KIIGMIII	M odification B u			M odification B ulletin			: 1/1	
Model: Model-J			Date	e: 25-Jan-02	2	No.: MG060001	1	
Modified Article: Parts Catalog Correction				Prepared	by: H.S	Someya	omeya	
From: Technical Se	ervices Dept., GTS Division							
Reason for	□ Parts catalog correction	☐ Vend	lor ch	ange	☐ To m	neet standards		
Modification:	☐ To facilitate assembly	☐ To improve reliability		()			
	☐ Part standardization	☐ Othe	r	ļ

Model: Model-J	Date: 15-Feb-02	No.: MG060002a

Model: Model-J P1b		Date	Date: 3-Apr-02		No.: MG060003
Modified Article: Guide Plate – Middle Registration			Prepared by: T. Itoh		
From: Technical Services Dept., GTS Division					
Reason for	□ Parts catalog correction	☐ Vendor change ☐ To improve reliability		☐ To n	neet standards
Modification:	☐ To facilitate assembly			()
	☐ Part standardization	☐ Other	☐ Other

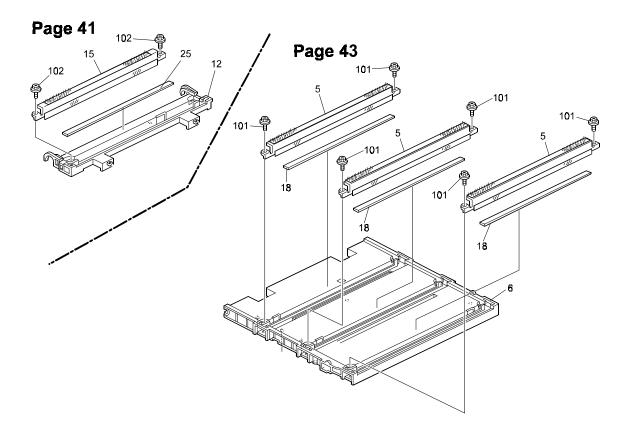
The following cushions have been newly added to absorb the vibration of the Transfer Charge Brushes, which can generate a low humming noise when a toner/dust buildup on the brush fibers increases the friction between the fibers and transfer belt.

On production machines after the cut-in numbers below, the cushions are attached directly onto the unit underneath the brushes. For machines in the field, the cushions should be attached according to the detailed procedure in RTB #RG060009.

Old part	New part	Description	Q'ty	Int	Page	Index	Note
number	number						
	G0603705	Cushion – Transfer Brush	0-1		41	25	new
	G0603705	Cushion – Transfer Brush	0-3		43	18	new

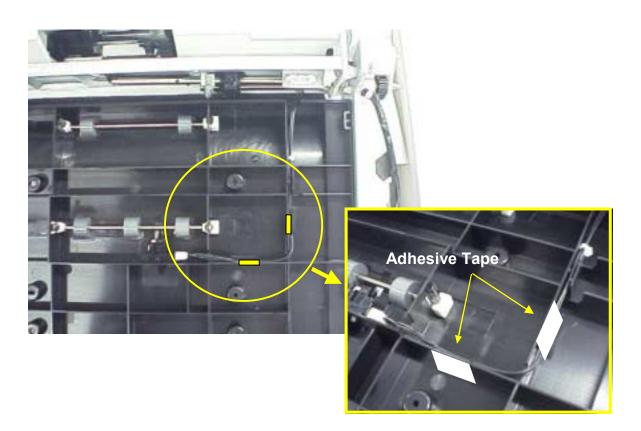
If this tape is necessary in the field, please order using the following (existing) part number:

Part number	Description	Q'ty	Int	Page	Index	Note
G0123897	Film – Toner End Sensor Harness	0-2		23	30	new

29. Electrical Section 1 (G060)

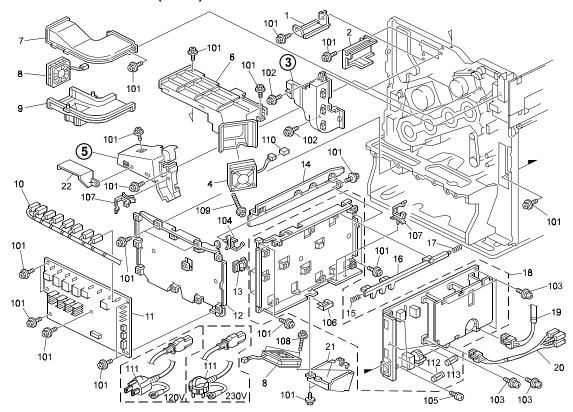
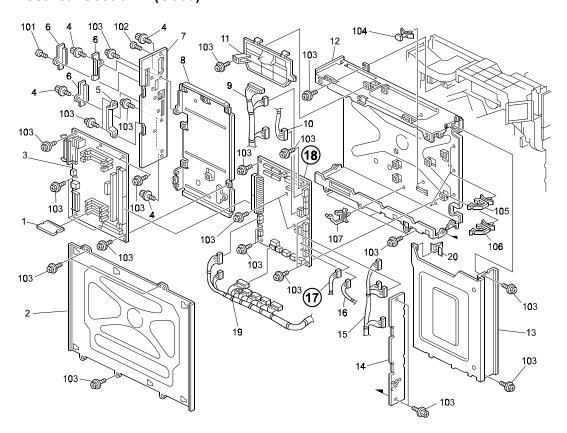
The following components were modified so that the clutch could be added. The new clutch is a component of the drive unit for the Bk development unit.

Note: Although the engine firmware was changed to ver B1.11H, the clutch engage/disengage control program had not been added yet. The clutch is therefore constantly engaged and keeps the fusing unit moving, as before.

Old part	New part	Description	Q'ty	Int	Page	Index	Note
number	number						
G0601100	G0771100	Drive Unit – K Development	1-1	X/X	57	4	
G0771154	G0771160	Bracket - Drum Drive	1-1	X/X	57	9	
G0601189	G0601560	Upper PSU Duct	1-1	X/X	71	4	
G0601557	G0601561	Duct – DC Motor Guard	1-1	X/X	65	5	
G0775452	G0775456	Harness – Left Main	1-1	X/X	67	17	
G0775069	G0775069A	BCU Board	1-1	X/O	67	18	
			1-1	X/O	85	*	
(Ver. B1.11G)	(Ver. B1.11H)	Engine main firmware	1-1	X/O

11. Paper Registration (G060)

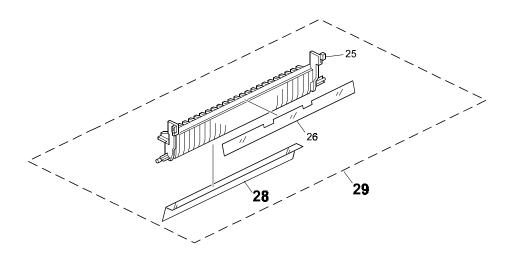
The following parts have been newly registered due to requests from the field.

Old part	New part	Description	Q'ty	Int	Page	Index	Note
number	number						
	G0602633	Guide: Middle: Lower	0 - 1		29	28	New
	G0602618	Guide Plate: Middle: Lower: Adhesion	0 - 1		29	29	New

7. 2nd Paper Feed Section (G060)

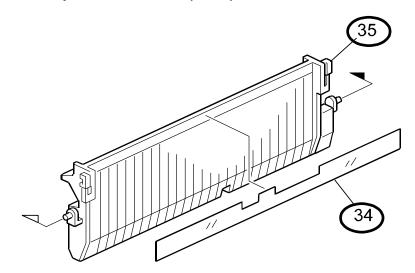
Please apply the following index corrections in the illustration to your Parts Catalogs.

Part number	Description	Page	Index
G0602629	Vertical Transport Guide	21	34
G0602730	Guide Plate	21	35

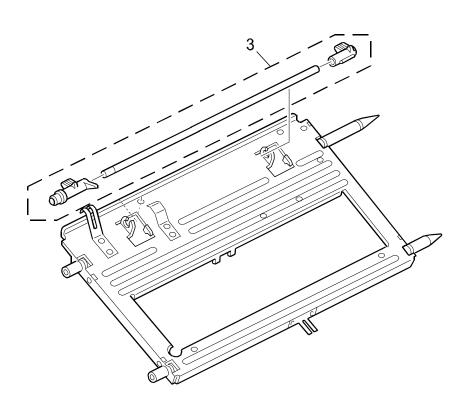
Delete the following P/N, descriptions and indexes from the illustration. These springs were deleted because they are provided only as part of the G0603694 Release Shaft (index 3 below), not individually.

Old part number	New part number	Description	Q'ty	Int	Page	Index	Note
AA066344	110111201	Rear Torsion Spring	1 – 0		41	23	
AA066345		Front Torsion Spring				24

17.Transfer Unit 3 (G060)

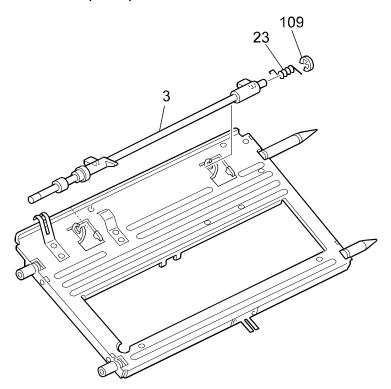
- 1) The machine is now shipped with the drum released from the transfer belt, i.e. with the release lever secured with tape in a second (new) unlocked position.
- 2) The parts listed below have been modified so that the front door can be closed with the lever in the second unlocked position for shipping. At installation, the lever must then be set to the locked position for the door to close.

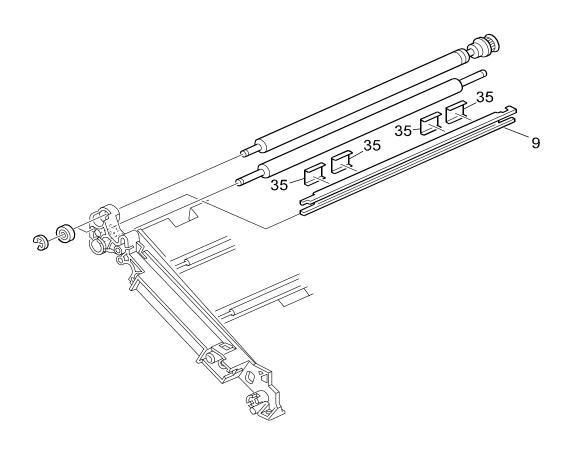
The following sheet has been added to ensure a proper gap between the Left Stay and Transfer Belt, as toner accumulated on the stay from toner scattering can be transferred to the transfer belt and cause an ID sensor misdetection.

Note: The four sheets are attached to the Left Stay, just to the left and right of both ID sensors (see illustration below).

Old part	New part	Description	Q'ty	Int	Page	Index	Note
number	number						
G0603840	G0603841	Transfer Unit	1 – 1	X/O	37	19	
	G0603707	Sheet: Stay: Left	4		39	35	NEW

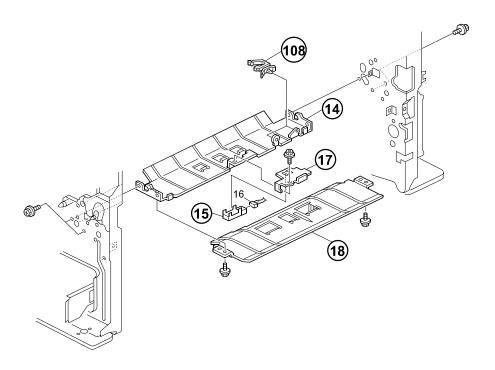
The following have been changed due to parts standardization with the J-P2. In addition, these new parts further ensure that the harness is led properly.

Old part	New part	Description	Q'ty	Int	Page	Index	Note
number	number						
AW020096	AW010098	Photointerrupter - GP2A231LRSA	1 - 1	X/X	29	15	*1
G0602625	G0802621	Guide Plate:Duplex:Exit:Upper	1 - 1	X/X	29	14	*1
G0602622	G0802622	Guide Plate:Duplex:Exit:Lower	1 - 1	X/X	29	18	*1
G0602634	G0802635	Bracket:Sensor:Paper Feed	1 - 1	X/X	29	17	*1
	11050511	Harness Clamp - LWS - 0306ZC	2		29	108	New
							*1
